Request	-	Special Use Permit for Gasoline and Fuel Sales
Location	-	1322 Bernath Parkway
Applicant + Design Professional	-	Matt Davis CESO, Inc. 2800 Corporate Exchange Drive, STE 400 Columbus, OH 43231
Developer	-	7-Eleven, Inc. 3200 Hackberry Road Irving, TX 75063
Owner	-	Akaashaman, LLC 3550 Mowry Ave, STE 301 Freemont, CA 94538

The applicant is requesting a Special Use Permit for a new gas station and convenience store at 1322 Bernath Parkway. The ±2.44-acre site is occupied by a vacant restaurant and is currently zoned RM12 (Multi-Dwelling Residential), which does not permit Gasoline and Fuel Sales. The applicant has applied for companion cases Z25-0038, a Zone Change from RM12 (Multi-Dwelling Residential) to CN (Neighborhood Commercial); and PUD26-0005 a request to remove the subject site from a Community Unit Plan. The CN (Neighborhood Commercial) district permits Gasoline and Fuel Sales with an approved Special Use Permit. This Special Use Permit review is based on the standards of the CN (Neighborhood Commercial) district and will be contingent on the approval of companion cases Z25-0038 and PUD26-0005.

SPECIAL USE PERMIT
TOLEDO CITY PLAN COMMISSION
REF: SUP25-0049
DATE:

SITE PLAN

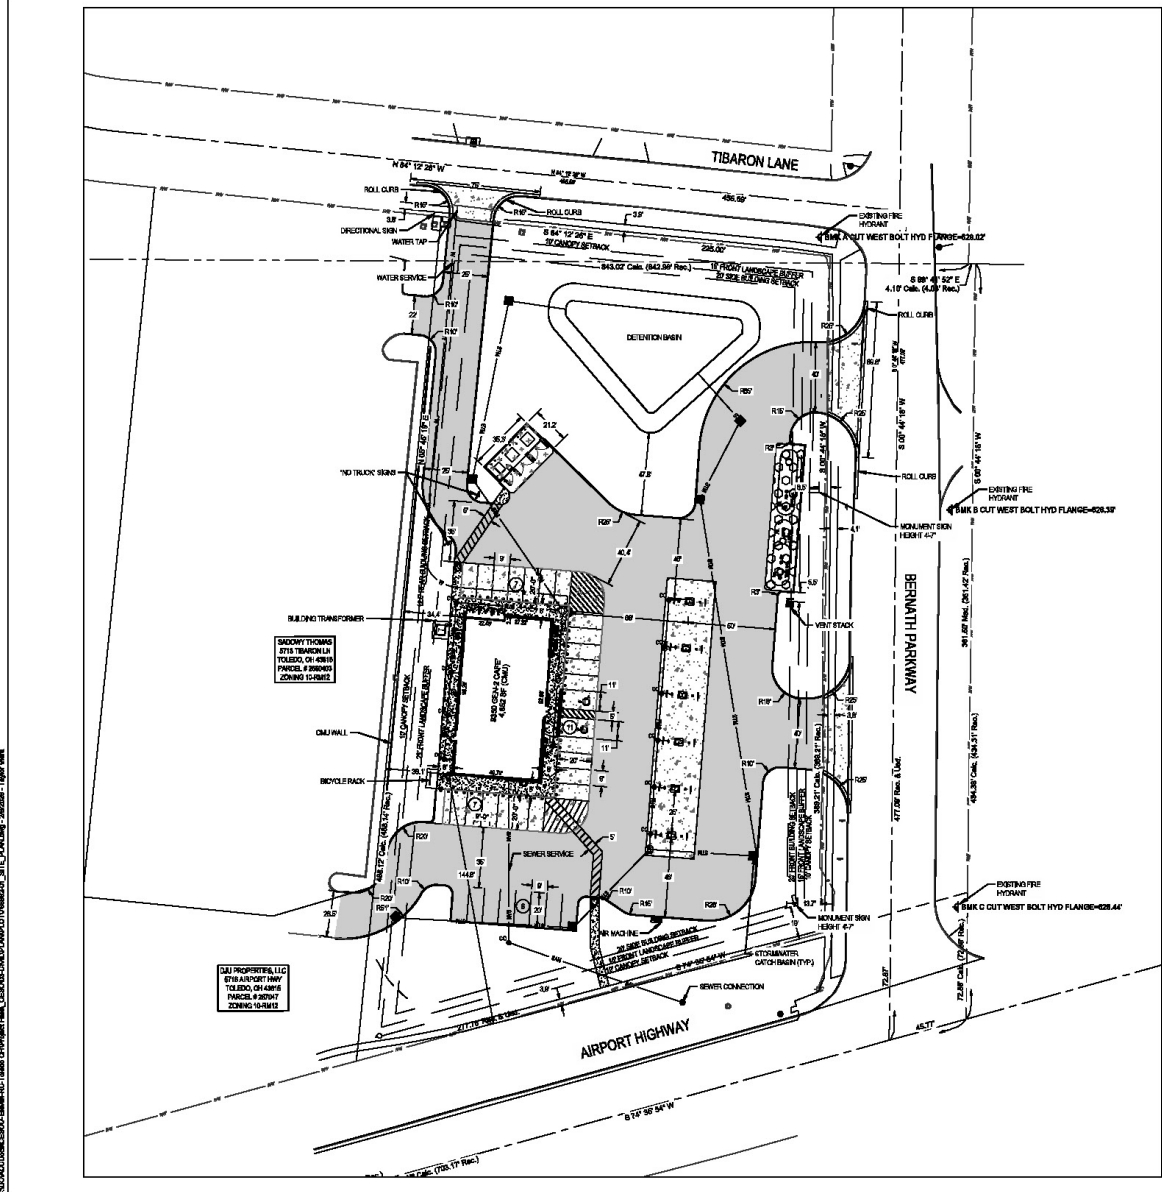
TMC§1107.1600 *Vehicle Stacking Areas* requires a minimum of one (1) ten- foot (10') by twenty-foot (20') stacking space at each pump island. Stacking spaces are not shown on the site plan. A revised site plan depicting such stacking spaces shall be submitted and is listed as condition of approval by the Division of Traffic Management.

The applicant has provided two (2) accessible parking spaces as required by TMC§1107.1700. One (1) of these spaces must be designed to accommodate an accessible van with an abutting eight-foot (8') wide aisle. The site plan indicates a five-foot (5') wide aisle between the two (2) proposed spaces. An eight-foot (8') wide abutting aisle shall be provided and is listed as a condition of approval. Lastly, these spaces must be identified with signs and pavement markings indicating them as reserved for persons with disabilities. Signs must be posted directly in front of the parking space at a height of no less than 60 inches and no more than 72 inches above pavement level.

23. Vehicle stacking at gas pumps must be clearly shown on drawings per TMC1107.1601. Stacking must be dimensioned to the parked spaces to the west and to the parking lot curb to the east.
24. Accessible parking signage must be posted directly in front of the parking spaces at a height of no less than 60" and no more than 72" above pavement level per TMC 1107.1704.
25. If one does not already exist, a cross access agreement is required with the adjacent property owner to the West.

30. Pursuant to Off-Street Parking Schedule "A," (TMC§1107.0304). A maximum of twenty-five parking spaces are allowed for this site. The submitted site plan shows thirty-three (33) parking spaces. **Not acceptable as depicted, removal of eight (8) spaces or an Alternative Parking Plan shall be provided.**

32. Any spaces reserved for the use by persons with physical disabilities shall adhere to the standards outlined in TMC§1107.1700. One (1) van accessible space with an eight-foot (8') drive aisle and one (1) car accessible space with five-foot (5') drive aisles are required. **Not acceptable as depicted, an eight-foot (8') wide abutting aisle shall be provided.**

EXTERIOR ELEVATIONS

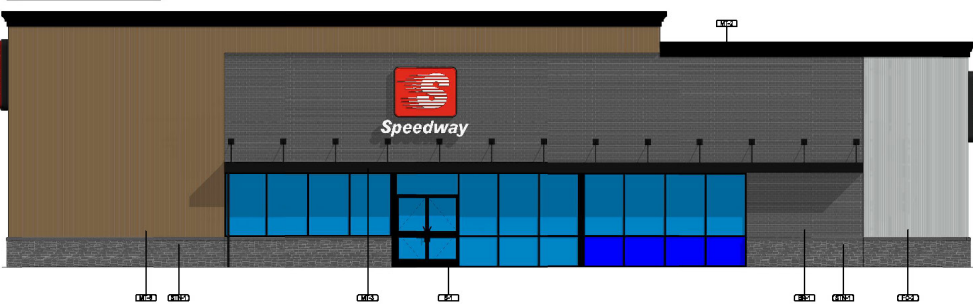
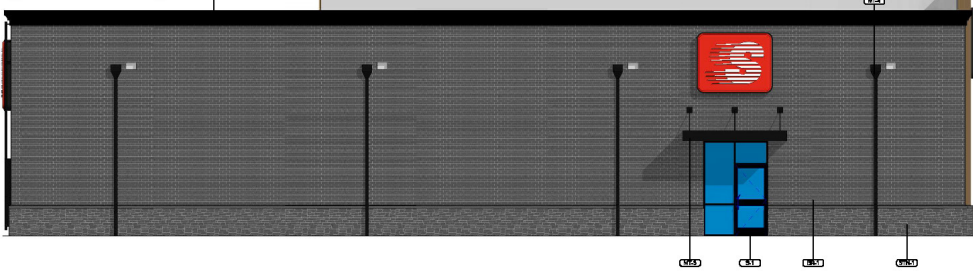
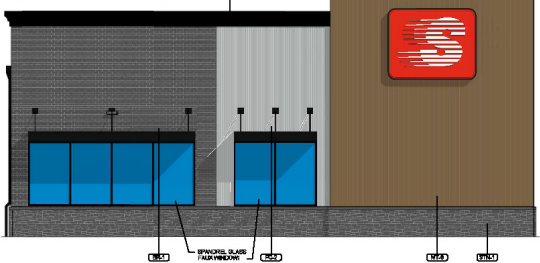
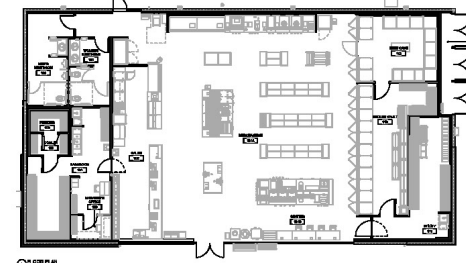
The proposed architectural metal is indicated as a twenty-four (24)-gage face sheet. Per TMC§1109.0502(D)(4) – metal panels shall have a minimum twenty-two (22)-gage face sheet. The use of twenty-four (24)-gage architectural metal is not permitted and is listed as condition of approval.

28. The hours of operation shall be limited to 5:30 a.m. to 1:00 a.m.
29. Support columns of gas canopies shall be brick, brick base, or other durable materials compatible with the principal building per TMC1104.0903(A). **Not depicted, revised canopy elevations depicting compatible building materials shall be submitted**

39. Per TMC§1109.0502(D)(4) architectural metal panels shall have a minimum twenty-two (22)-gage face sheet. **Not acceptable as depicted on building elevations.**

LANDSCAPE PLAN

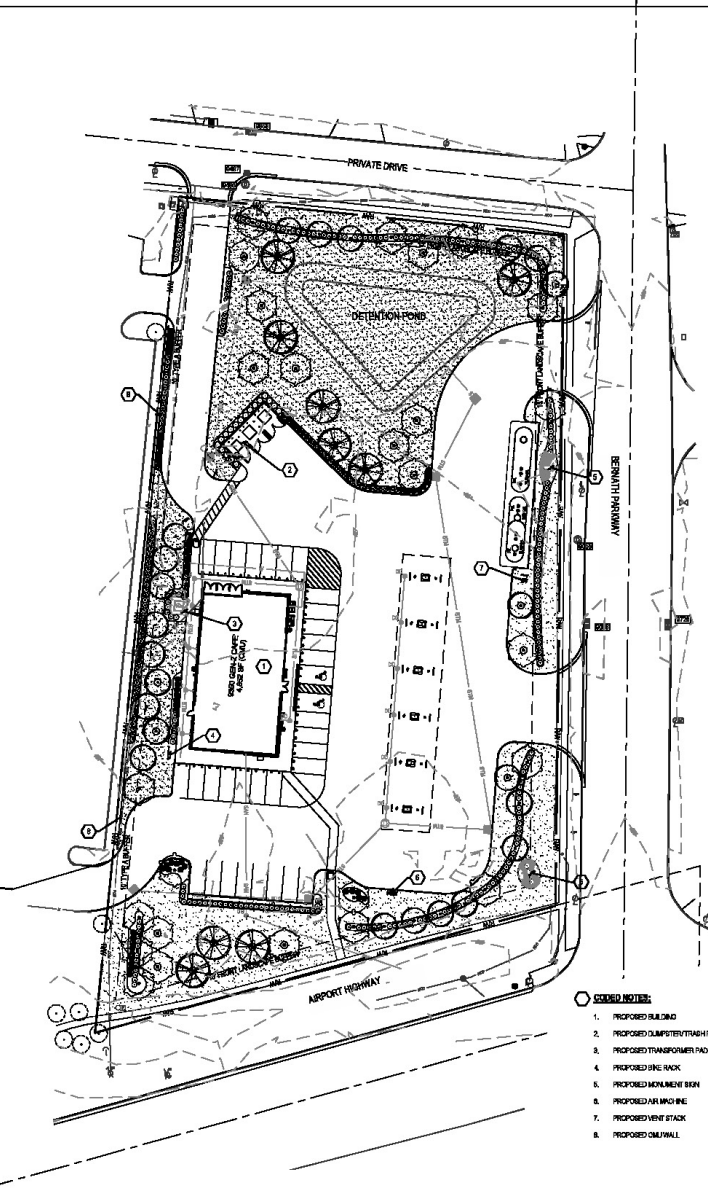
A Type A landscape buffer is required along the western property line. This landscape buffer shall be a minimum ten (10') feet in width and include a solid fence or wall six (6') to eight (8') feet in height, and plantings of four (4) trees and fifteen (15) shrubs for every one hundred linear feet (100'). The western property line is ± 488 linear feet, requiring twenty (20) trees and sixty (60) shrubs. The landscape plan depicts a six (6') foot tall wall, with thirteen (13) trees and seventy-eight (78) shrubs. An additional seven (7) trees shall be provided as a part of the Type A landscape buffer along the western property line, and is listed as condition of approval.

- b. A ten-foot (10') wide Type A landscape buffer consisting of a solid wall or fence six-feet (6') to eight-feet (8') in height, four (4) trees and fifteen (15) shrubs for every one-hundred (100) linear feet shall be provided along the western property line abutting the residential district. **The proposed width, wall, and number of shrubs is acceptable however, an additional seven (7) trees shall be provided.**

- e. Foundation plantings shall be required along the portions of the building visible from the right-of-way. **Acceptable as depicted.**
 - f. Plantings at the main entrance of the building shall be provided. **Not acceptable, shall be depicted on revised landscaping plan.**

- n. The location and direction of any proposed lighting. **Lighting is to be directed away from adjacent residential properties.**
 - o. Per TMC§1108.0203(G), dumpsters shall be screened on all four sides with materials of evergreen plantings, fencing, a wall, or a combination thereof with a minimum height of six (6') feet. **Not acceptable, dumpster screening detail and materials shall be submitted for approval on revised landscaping plan.**
